CODE AMENDMENT FORM

ITEM NO:	(DCA USE ONLY)	PAGE 1 OF			
			IECC R40)2.4.1.3	
CODE: GA En	ergy Code 2020 Amendments	SECTION:	(GA Ame	ndments)	
	Mike Barcik, Southface, Abe Kruger, SK			·	
	Collaborative, Diana Burk, New Buildings				
	Institute, Eric Lacey, Responsible Energy				
PROPONENT:	Codes Alliance	DATE:	12/10/202	.2	
<u>m</u>	ikeb@southface.org; diana@newbuildings.org	; abe@skcollab	orative.com	n; <u>eric@reca</u> -	-
EMAIL: <u>co</u>	des.com				
ADDRESS: 24	1 Pine St NE Atlanta GA 30308				
TELEPHONE N	UMBER: (404) 604-3620	FAX N	UMBER:	(404) 872-:	5009
CHECK 🗵	Revise section to read as follows:	Add ne	w section to r	ead as follows:	
ONE:	Delete section and substitute the following:	Delete	without substi	itution:	
LINE THROUG	H MATERIAL TO BE DELETED:	UNDERLINE	MATERIA	L TO BE A	<u>DDED</u>
Approve	Approve as amended (DCA STAFF O	NLY) 🗌 Dis	sapprove	Withdra	wn

R402.4.1.3 Low-rise R-2 multifamily testing (<u>Mandatory</u>). Low-rise R-2 multifamily dwellings shall be tested to less than 7.0 <u>5.0</u> air changes per hour at 50 Pascals (ACH50).

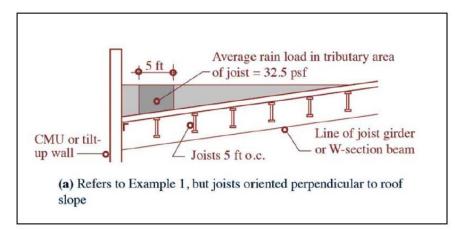
The most significant change in the evaluation of ponding instability addressed in ASCE 7-16 is structural orientation. The load on the joists is much greater if the joists are oriented parallel to the wall to which the water drains than if the joists are perpendicular to the wall. Below is example of a collapse in Dallas, TX, where ponding instability and structural orientation was an issue. The accumulation of water on the 1st and 2nd joists that were parallel to the wall was much greater than if the joists had been perpendicular to the wall. This condition resulted in excessive rainwater load on the joists. The photograph below, left shows the roof collapse, and the photograph below, right shows the joists' structural orientation.

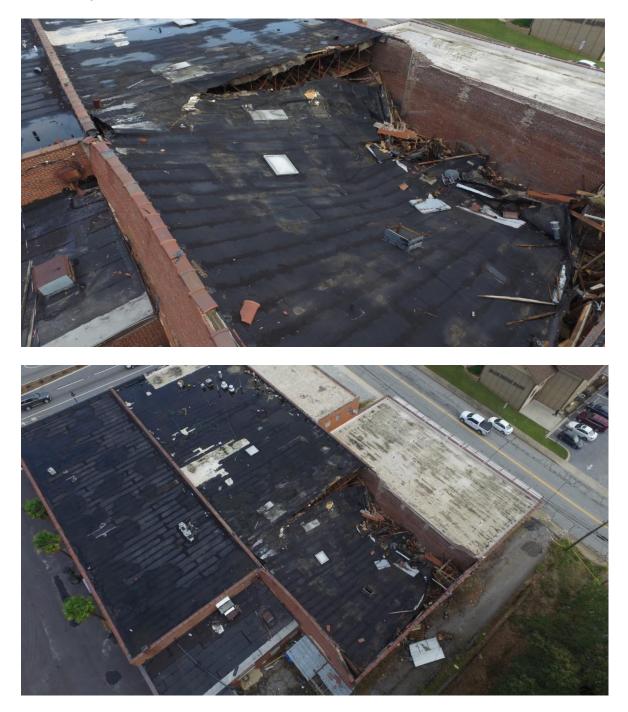
In addition, Jeffrey Levine (see Ref. 6) conducted a review of US rainfall intensity data reports and various plumbing codes from 1935 to the present. He found that "plumbing codes have remained relatively static, rarely contain current rainfall intensity data, and truly represent a minimum standard with regard to the design of roof drainage systems."
